FoxFire / DeerField Temperature Sensor Upgrade Kit

SKU# 250-04548

Deerfield/Foxfire Temp Sensor Notice

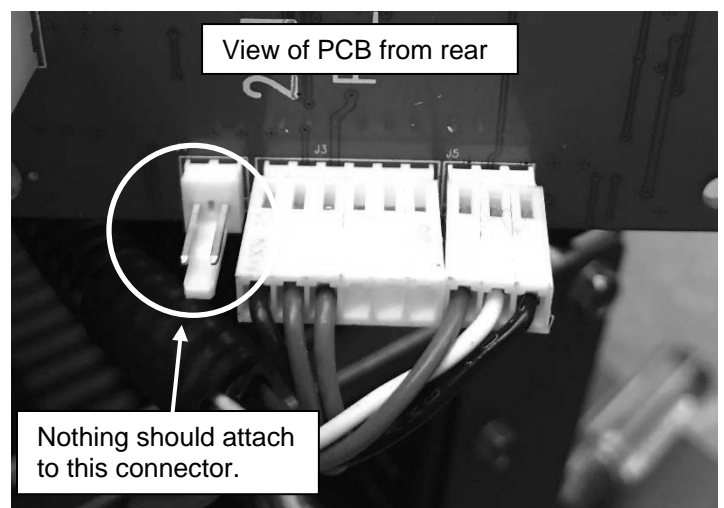
We have received reports of stoves showing errant temperature readings, on the user interface, after installation of the extended temp. sensor used in the kit (Deerfield) or installed as an upgrade (Foxfire).

The kit required the removal and replacement of the Power Control Board (PCB) and the temperature sensor for the stoves internal thermostat. If the connection of the sensor to the board is incorrect, the temperature issue may occur. If you experience a stove that shows room temperatures in excess of 140°F, please check the connections of the temperature sensor to the board (see below). It is imperative that Installation of the connectors on the back on the replacement board are connected in exactly the same location and orientation as they were installed originally from the factory.

NOTE: It is possible to connect the sensor one pin off, causing the inaccurate reading.

When verifying the alignment of the connectors check the following carefully:

- The locking tabs on the connectors should be facing the bottom of the board. When done correctly, the connector will “click” into place on the board.
- There are three connection points on the board that are all in a row. One has (2) pins, the middle one has (6) pins and the last one has (3) pins. **ONLY THE 6 PIN AND THE 3 PIN CONNECTOR SHOULD BE USED.** After installation the (2) pin connector should still be empty.
- If the User Interface still shows a temperature of 140°F or more, disconnect the temperature probe from the board and connect the original “internal” temp probe that is part of the stoves wire harness. If the temperature reads properly, then the replacement temp probe was faulty and should be replaced using sku# 250-04548. Provide the serial number of the stove when ordering.

NOTE: Once improper connection of the probe has been ruled out, the temp probe is likely the issue. Do not replace the PCB or the User interface for this issue until the connections are thoroughly checked **AND** you contact Technical Support for assistance (425-609-2500).

If the connections are correct and the problem persists, perform the voltage test that is explained in detail in the “Testing DC voltage from the Temperature Sensor” section of the “Deerfield/Foxfire Troubleshooting and Service Guide”, available in the back office.
